# **BURLINGTON BYPASS: ROAD SAFETY AUDIT**

November 2006

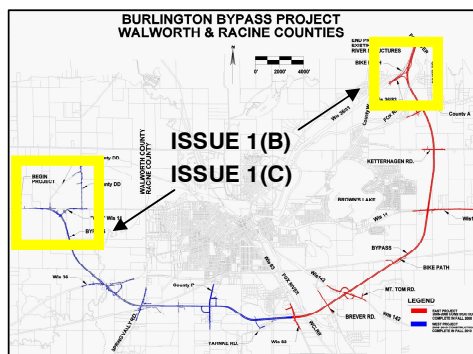
**Safety Issue 1(a):** The combination of high speeds and frequent horizontal curves may generate an increased risk of off-road (lane departure) collisions.

**Safety Issue 1(a) Description:** The Bypass follows a semi-circular alignment that incorporates many horizontal curves (*right*). The presence of frequent horizontal curves, even if compliant with AASHTO criteria, can be expected to result in an increased risk of run-off-road collisions when drivers fail to follow a changing alignment. Aggravating factors include:

- the high speed environment (mainline design speed of 60 mph and posted speed of 55 mph),
- the limited use of lighting,
- the possibility of fog associated with the surrounding wetlands and streams,
- the potential presence of wildlife on the road in this rural area.

Safety Issue			Suggestions
1a	1b	1c	
			1. <i>Enhance delineation using low-cost measures:</i>
√	√	√	<ul style="list-style-type: none"> <li><i>Six-inch edgeline:</i> To assist drivers, particularly at night or in fog, a wide retroreflective edgeline may be used along the entire Bypass alignment. A typical edgeline is four to six inches wide; the design team may consider using a width of six inches (i.e., the upper end of this range). Discussions during the preliminary findings meeting (August 17, 2006) indicate that test application of six-inch edgelines is currently scheduled for 2008 on I-94 in Waukesha County. It is noted that the use of six-inch edgelines may be inconsistent with state policy, and may therefore require justification (see Issue 7 below).</li> </ul>
√		√	<ul style="list-style-type: none"> <li><i>Rumble strips:</i> To alert drivers who have left the travel lane and entered the shoulder, shoulder rumble strips may be considered. NCHRP Report 500 (<i>Volume 6: A Guide for Addressing Run-Off-Road Collisions</i>) cites several before/after studies of the effectiveness of shoulder rumble strips, and concludes that a “best guess” estimate is a 20- to 30-percent reduction in single-vehicle run-off-road collisions on rural freeways with the use of</li> </ul>

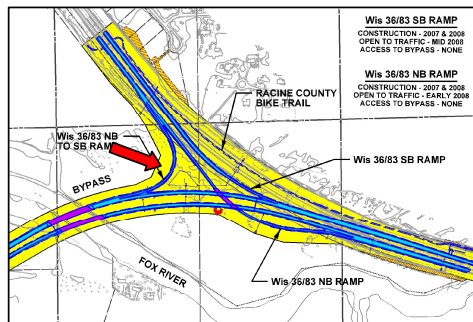
**Safety Issue 1(b):** At the north interchange (*right*) of STH 36/83 and the Bypass, a tight ramp configuration may result in an increased risk of run-off-road (lane departure) crashes.

**Safety Issue 1(b) Description:** Severe constraints at the eastern end of the Bypass have resulted in a ramp design based on a design speed of 30 mph and posted speed of 25 mph. The ramp connects two roads (STH 36/83 and the Bypass) having posted speed limits of 55 mph. Drivers who fail to slow sufficiently on the ramp have an increased risk of off-road crashes and, in the case of trucks, rollovers. Aggravating factors contributing to an increased risk of collision include:

- possible icy pavement on this section of road, which is on structure;
- a high driver workload on the ramp, where entering drivers must merge with higher-speed traffic on the through route while navigating a reverse curve.

√		<p><i>3. Provide warning signs.</i> In addition to the chevron signs discussed in Suggestion (1) above, other warning signs (some of which may already be proposed by the design team) may be considered to assist drivers on the north interchange ramp, where the driver workload is high and the risk of truck rollovers may be high:</p> <ul style="list-style-type: none"> <li>○ An advance W1-1 (Horizontal Alignment) warning sign and W1-13 (Truck Rollover) sign (<i>right</i>), with advisory W13-1 speed plaques, may be posted in advance of the curve to warn drivers that they will need to slow for the curve ahead. </li> <li>○ A W13-3 (Advisory Ramp Speed) sign may be used on the ramp to advise drivers of the slower speed limit.</li> <li>○ W4-1 (Merge) signs may be used on the ramp and mainline to advise drivers that ramp traffic must merge at the ramp terminus.</li> </ul> <p>Posting a large number of warning signs on the ramp and its approach may contribute to a high driver workload as drivers attempt to understand the signs, adjust their speed appropriately, and accomplish a safe merge. Prioritization of the hazards on the tight curve, and the resulting signing requirements, may be beneficial.</p>

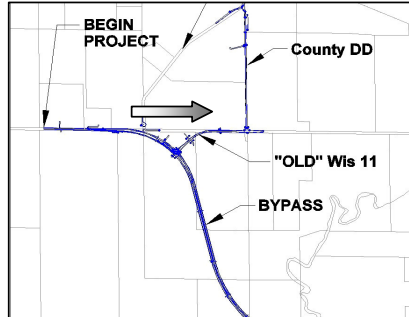
**Safety Issue 1(c):** At the west end of the project, drivers may expect to follow the abandoned alignment of STH 11, resulting in an increased risk of off-road (lane departure) crashes.

**Safety Issue 1(c) Description:** The design team has diverted the existing STH 11 alignment to intersect the new Bypass alignment at a right angle (*right*). Vestiges of the old alignment such as pavement, landscaping, or a roadside utility corridor may confuse inattentive eastbound drivers. Drivers who follow the old alignment may enter the opposing lanes of traffic or the roadside.

√	<p><i>4. Use a berm to obstruct drivers' view of the abandoned highway alignment.</i> During the preliminary findings meeting (August 17, 2006), the design team discussed the possibility of providing a berm at the intersection of STH 11 and the Bypass. The berm could be positioned to obstruct eastbound drivers' view of the old STH 11 alignment. The berm should be outside the roadside clear zone (or designed with recoverable slopes), and should not obstruct sightlines at the new intersection.</p>

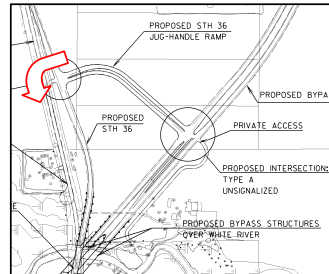
**Safety Issue 3(b): A high left-turn volume from the Bypass ramp onto STH 36 may increase the risk of rear-end and left-turn collisions on STH 36.**

**Safety Issue 3(b) Description:** Traffic forecasts show a high left-turn volume from the Bypass ramp onto southbound STH 36 (right). The high turning volume at this unsignalized intersection may cause queuing on the ramp (where sight distance is limited by a horizontal curve for drivers exiting the Bypass), and an increased risk of left-turn collisions on STH 36. The risk and potential severity of collisions is increased by high approach speeds (posted speed 55 mph) on STH 36.

**Suggestion:** Install a signal or roundabout at the ramp intersection. The introduction of a signal at the intersection of STH 36 and the ramp may be considered if WMUTCD traffic signal warrants are satisfied. Alternatively, the design team may consider providing a roundabout at this intersection to accommodate the substantial through and left-turn volumes. A preliminary review suggests that sufficient right of way is available to accommodate a roundabout.

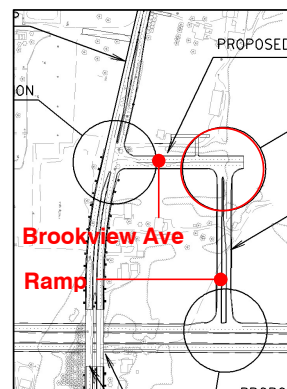
**Safety Issue 3(c): Substantial turning movements at the intersection of the CTH P ramp and Brookview Avenue may lead to turning conflicts and queuing on the ramp.**

**Safety Issue 3(c) Description:** The CTH P ramp intersects Brookview Avenue at a "T" intersection (red circle, right). Traffic forecasts show a substantial volume on the ramp and Brookview Avenue, reflecting existing demand as well as future development of an industrial park on the site adjacent to the intersection. All-way STOP control at the intersection may lead to substantial delays, resulting in undesirable queuing on the ramp. Two-way STOP control, which would likely require drivers exiting the industrial park and drivers on Brookview Avenue to stop, may result in driver confusion when stopped drivers fail to anticipate that the ramp approach is uncontrolled.

**Suggestion:** *Install a roundabout at the “T” intersection.* The design team may consider providing a roundabout at this intersection to accommodate the substantial through and turning volumes on the ramp and Brookview Avenue. A preliminary review suggests that sufficient right of way is available to accommodate a roundabout. Although the industrial park is not expected to be developed until after completion of the Bypass, construction of a roundabout at the time of Bypass construction may be less costly than future re-configuration of the “T” intersection.

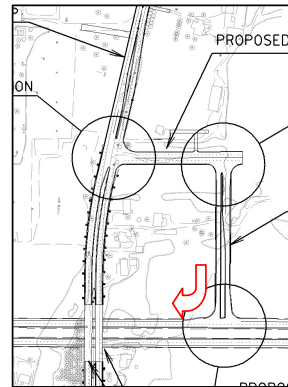
**Safety Issue 3(d): Drivers turning right from the CTH P ramp may interfere with through traffic on the Bypass.**

**Safety Issue 3(d) Description:** Interference between right-turn movements from the ramp (*red arrow, right*) and through traffic on the Bypass can be anticipated, since a limited deceleration and acceleration taper is provided on the Bypass. Interference between right-turning and through traffic is likely at this intersection, since the ramp provides access to trucks (which typically have slow acceleration characteristics) associated with the JW Peters Quarry and the future industrial park.

**Suggestions:** A parallel acceleration lane on the Bypass for right-turning traffic may be considered to allow right-turning drivers to accelerate for a longer distance before merging into the right Bypass lane. At this location, a longer acceleration lane may require widening of the adjacent overpass structure.

An offset right turn lane (*example shown above under Safety Issue 3(a)*) on the Bypass may be considered. The offset lane would provide a longer deceleration distance for drivers turning right onto the ramp, and would position these decelerating vehicles further right to reduce interference with sightlines between through traffic on the Bypass and drivers entering the Bypass (turning either left or right).

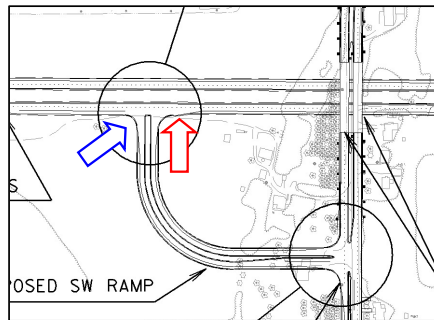
**Safety Issue 4(a): Auxiliary lane lengths at five ramps appear to be short, and ramp entry turn radii appear to be abrupt.**

**Safety Issue 4(a) Description:** Five interchange ramps or intersections include short right-turn acceleration lanes (usually of a tapered design), often limited by adjacent structures or upstream features. The short tapered acceleration lanes limit right-turning drivers' ability to accelerate to highway speed before merging into the right through lane. Slower vehicles, especially slowly-accelerating trucks, may interfere with through traffic on the Bypass, increasing the risk of rear-end and sideswipe collisions. Drivers who fail to merge may leave the travel lane, resulting in off-road and fixed-object collisions.

**Example (ramp at CTH P and the Bypass):**  
A short acceleration lane is provided (red arrow, likely due to the overpass structure), and the right-turn radius onto the ramp (blue arrow) appears to be abrupt.

1. *Provide an offset right turn lane:* An offset right turn lane (example shown above under Safety Issue 3(a)) on the Bypass may be considered. The offset lane would provide a longer deceleration distance for drivers turning right onto the ramp, and would position these decelerating vehicles further right to reduce interference with sightlines between through traffic on the Bypass and drivers entering the Bypass (turning either left or right).

2. *Provide a parallel acceleration lane:* A parallel acceleration lane on the Bypass for right-turning traffic may be considered to allow right-turning drivers to accelerate for a longer distance before merging into the right Bypass lane. Longer acceleration lanes may particularly assist older drivers, whose ability to view mainline traffic may be compromised. At most interchange locations, a longer acceleration lane may require widening of the adjacent overpass structure.

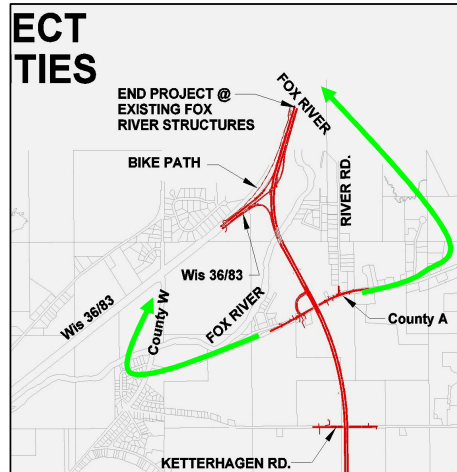
**Safety Issue 4(b): Unsignalized left turns at at-grade intersections on the Bypass generate a risk of high-speed left-turn collisions, which may be potentially severe.**

**Safety Issue 4(b) Description:** Three ramp or road intersections involve an unprotected left turn across two lanes of opposing or crossing Bypass traffic. The risk and potential severity of left-turn crashes is aggravated by:

**Example (ramp at STH 36 and the Bypass):** Left turns from and onto the ramp must cross two lanes of Bypass traffic.

Signalization of ramps may be considered, but the addition of two signals to the Bypass may be operationally undesirable. Although signalization remains an option, three alternative suggestions can be considered by the design team:

1. *Restrict left turns from the CTH A ramp onto the Bypass.* To reduce the risks associated with left turns from the CTH A ramp onto the Bypass, the ramp configuration may be revised to eliminate this movement. A review of the road network in the area of the CTH A interchange indicates that convenient alternative routes, which would involve less apparent risk, are readily available for users of CTH A to access STH 36/83 (which is the destination of drivers turning left from the CTH A ramp onto the Bypass) (*right*).

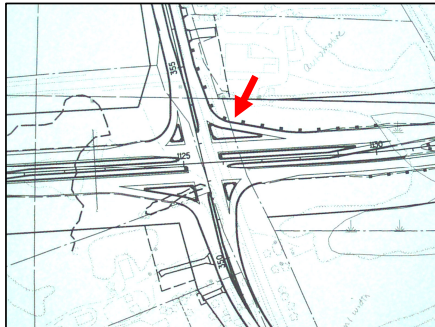
**Safety Issue 6(b): A guardrail obstructs pedestrian access to a signalized intersection.**

Design drawings show a continuous guardrail in the northeast corner at the intersection of the Bypass with STH 83. The guardrail obstructs pedestrian access to the intersection, which has pedestrian crossing facilities.

2. *Provide barrier break to allow pedestrian access.* Design drawings may be amended to provide a crashworthy break in the barrier at the STH 83 intersection to allow pedestrian access to the intersection without compromising the performance of the barrier in a crash. Pedestrian visibility should be considered in the redesign of the barrier.

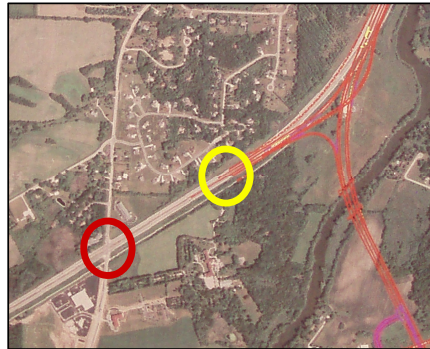
**Safety Issue 6(a): An at-grade bicycle trail crossing over Hwy 36/83 exposes cyclists to several lanes of high-speed traffic.**

**Safety Issue Description:** The new north interchange will require relocation of an existing County bicycle trail from the south side of STH 36/83 to the north side of the highway. Bicyclists will be directed to an at-grade mid-block crossing over STH 36/83 (*right*), where they will cross a divided four-lane highway having a posted speed of 55 mph.

The risk of collision is increased by the high speeds, the need to cross multiple lanes (*right*), absence of lighting, potentially high proportion of trucks (which have reduced braking ability), and the possible presence of young and/or inexperienced cyclists on the County bike trail.

1. *Relocate bicycle crossing:* The design team may consider relocating the planned bicycle trail crossing from its proposed location to the signalized intersection at CTH W (red circle at right). Relocation of the crossing would allow cyclists to cross with the signal at a lighted intersection, where drivers may more readily expect and see them.

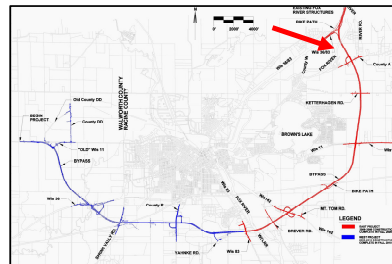
**Safety Issue: Icy and foggy conditions may aggravate the risk of collisions.**

**Safety Issue Description:** The Bypass is located in a wetlands area where the alignment will require three river/lowland crossings. These environmental elements increase the risks associated with:

- *Icy Pavement:* Since bridges typically freeze before adjacent road segments on grade, drivers may fail to anticipate icy conditions on bridges. The risks associated with a slippery road surface are substantial at the north interchange bridge (*red arrow, right*), as described under Issue 5 above.
- *Foggy Conditions:* Foggy conditions can be frequently encountered in wetland and river areas. Visibility may be unexpectedly and intermittently reduced in foggy areas.

*Introduce measures to increase driver guidance and warning.* Improved driver guidance and warning may be achieved using the following methods:

- roadway and/or intersection lighting (discussed in Issue 2),
- wide 6-inch edgelines (discussed in Issue 1),
- shoulder and centerline rumble strips (discussed in Issue 1).
